STAFF RECOMMENDATION

**1214 Calvin Avenue
September 16, 2015**

Application: New construction – outbuilding (detached accessory dwelling unit);
Setback determination

District: Lockeland Springs-East End Neighborhood Conservation Zoning Overlay

H0.1

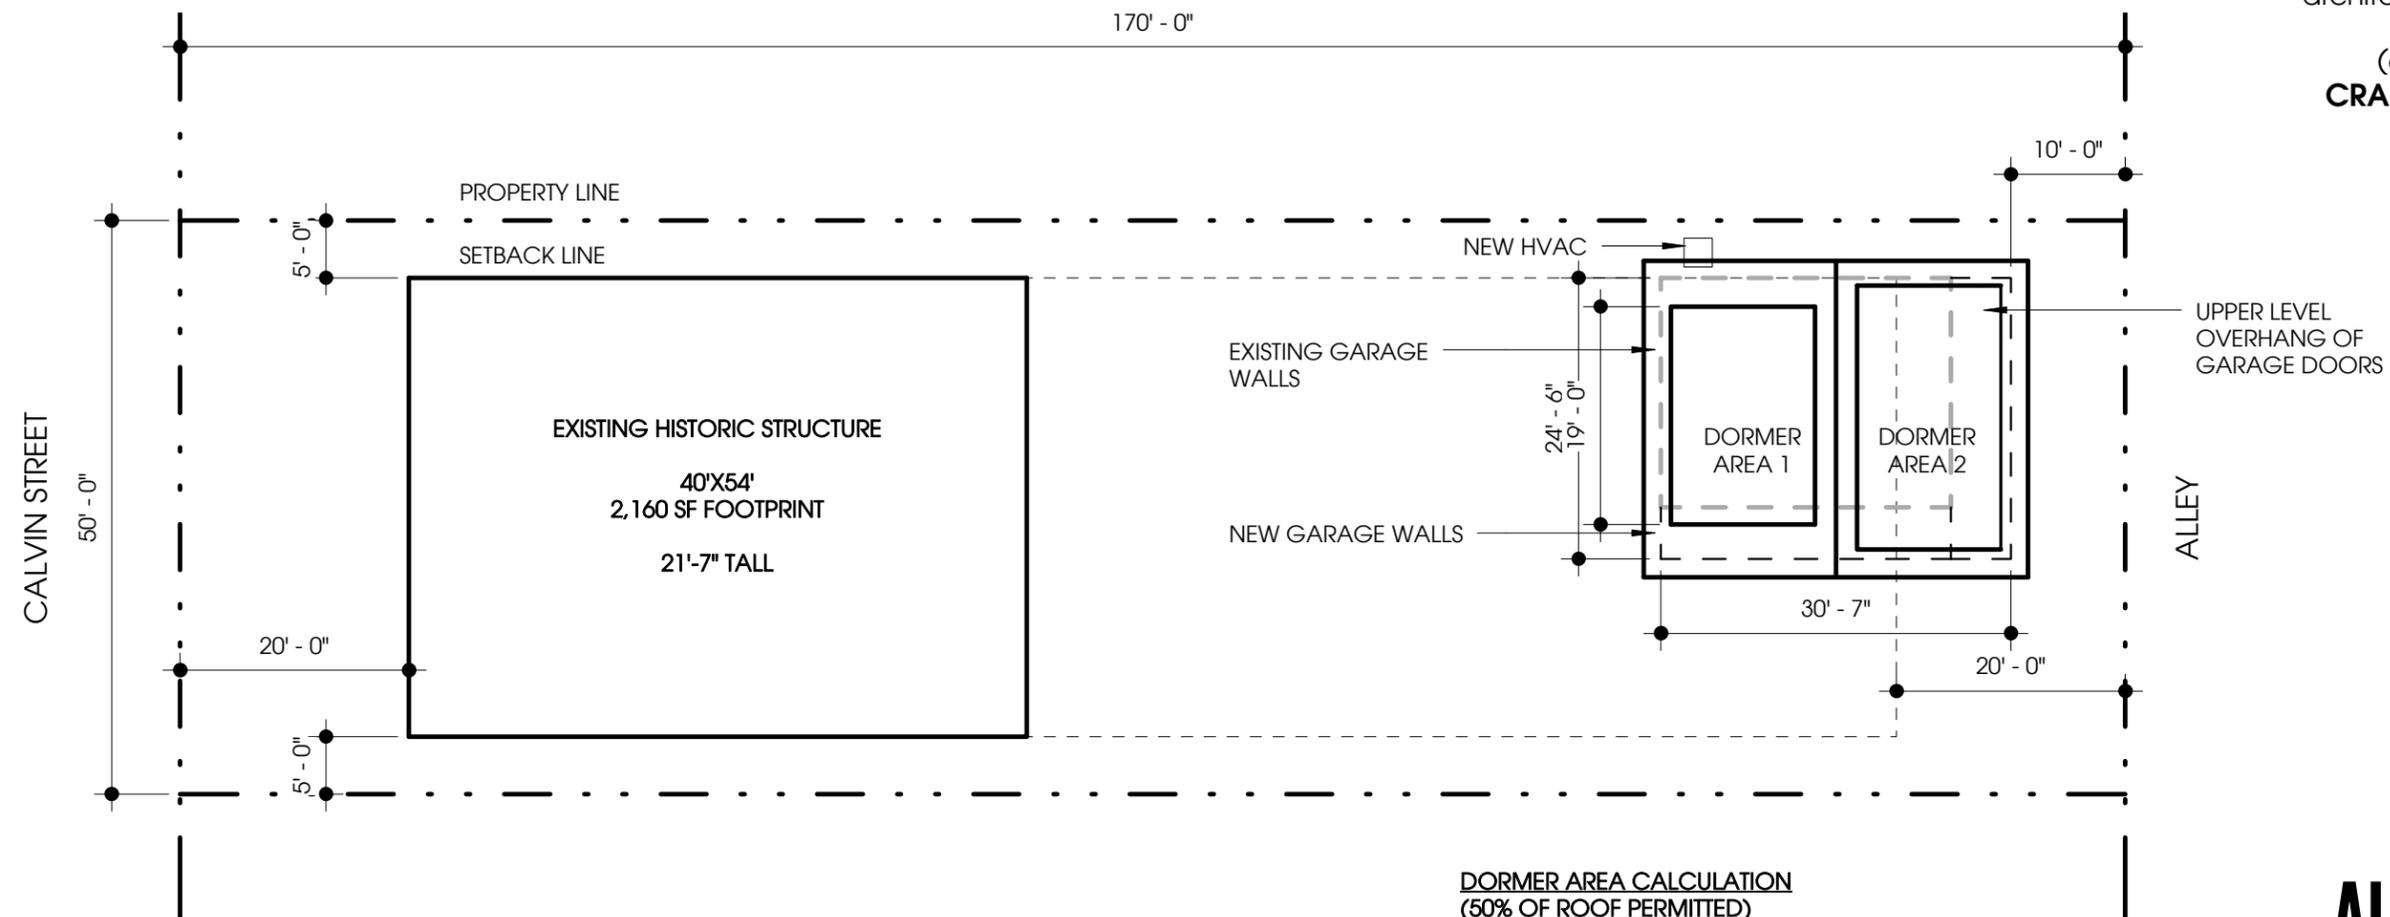
Analysis and Findings: The applicant proposes to construct a detached accessory dwelling unit (DADU) at the rear of the lot. The structure would require that the Commission determine the appropriateness of a ten foot (10') rear setback.

The new outbuilding requires a rear setback determination. When an outbuilding has a footprint greater than seven hundred square feet (700 sq. ft.), base zoning requires that the structure be located twenty feet (20') from the rear property line and five feet (5') from the side property lines. In this instance, the structure is located at least five feet (5') from the side property lines, but it is located ten feet (10') from the rear property line. Staff finds that the proposed rear setback is appropriate because a ten foot (10') setback is the standard rear setback for structures that are seven hundred square feet (700 sq. ft.) or less. Also, historically, outbuildings were located at the rear of the property, close to the rear property line. A ten foot (10') rear setback is more historically appropriate than a twenty foot (20') rear setback. In addition, the ten foot (10') rear setback allows for more space between the primary structure and the DADU. Staff recommends approval of the setback determination.

Staff recommends approval of the detached accessory dwelling unit with a ten foot (10') rear setback, with the following conditions:

H2.0

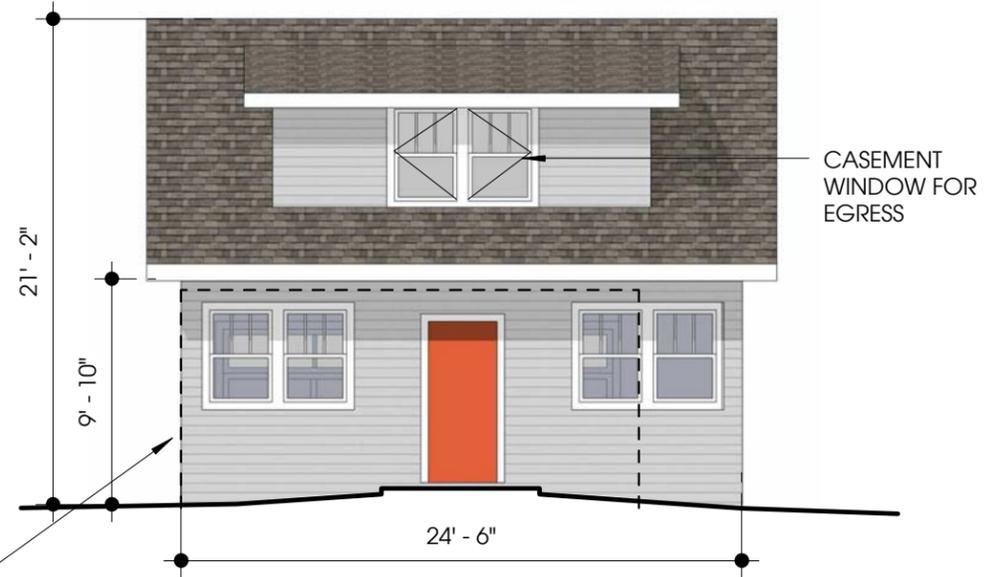
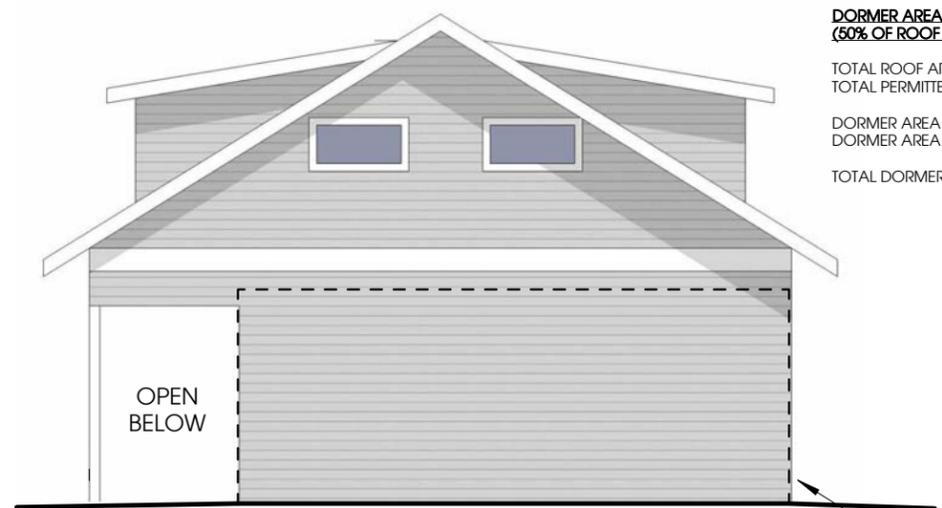
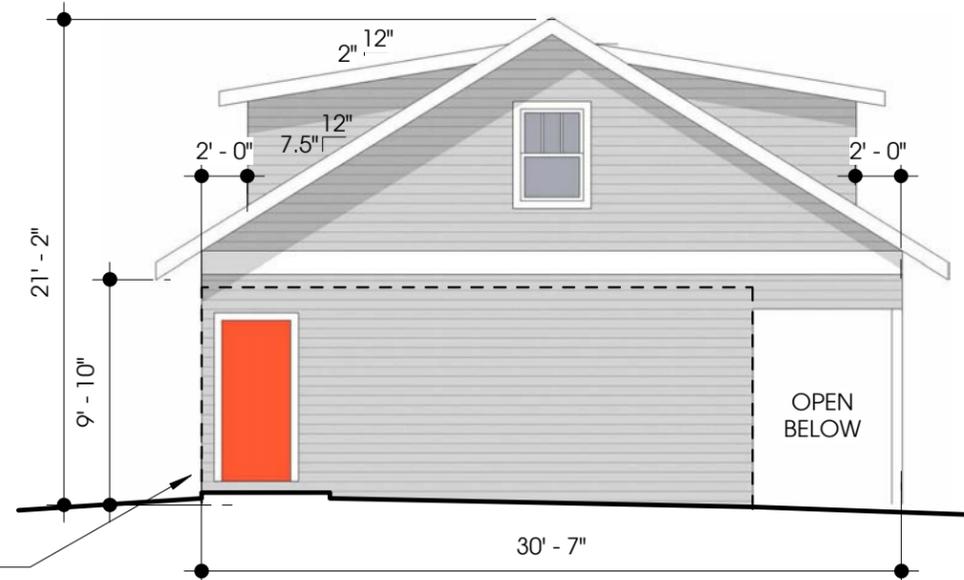
The proposed outbuilding will have a side-gabled roof with shed dormers on both the front and rear-facing slopes. Metro Ordinance 17.16.030.F.8.b states that “The detached accessory dwelling may have dormers that relate to the style and proportion of windows on the detached accessory dwelling and shall be subordinate to the roof slope by covering no more than fifty percent of the roof.”

The applicant has provided an analysis of the dormers’ roof surface area in relation to the total surface area of the primary roof, based on the length of the rafters by the width measured fascia to fascia. Staff finds this is not a good indicator of whether or not a dormer is subordinate to a primary roof because it compares roofs with different pitches not in the same plane. Additionally, this method is too easily be affected by slight changes to the pitch or the amount of overhang on the eaves. To compare roofs consistently in the past, the Commission has linearly measured a roof from side wall to side wall to determine a baseline for size of roof slope, and allowed the dormers for each slope to comprise up to fifty percent (50%) of that amount.

The width of the building, excluding the eave overhangs, is twenty-four feet, six inches (24’-6”) wide. The dormer facade facing the front will be sixteen feet, six inches (16’-6”) wide, or sixty-seven percent (67%) of the primary roof. The dormer facing the rear will be twenty feet, six inches (20’-6”) wide, or eighty-three percent (83%) of the primary roof.

Staff finds that the scale of the dormers as proposed do not meet Metro Ordinance 17.16.030.F.8.b, and recommends that they both be reduced to no greater than twelve feet, nine three (12’-3’) wide.

1. The dormers are reduced to twelve feet, nine three (12’-3’) wide in width.
2. Staff approves the final details, dimensions and materials of windows and doors prior to purchase and installation;
3. Staff approves the roof shingle color; and
4. Staff receives a copy of the filed restrictive covenant for the detached accessory dwelling unit.
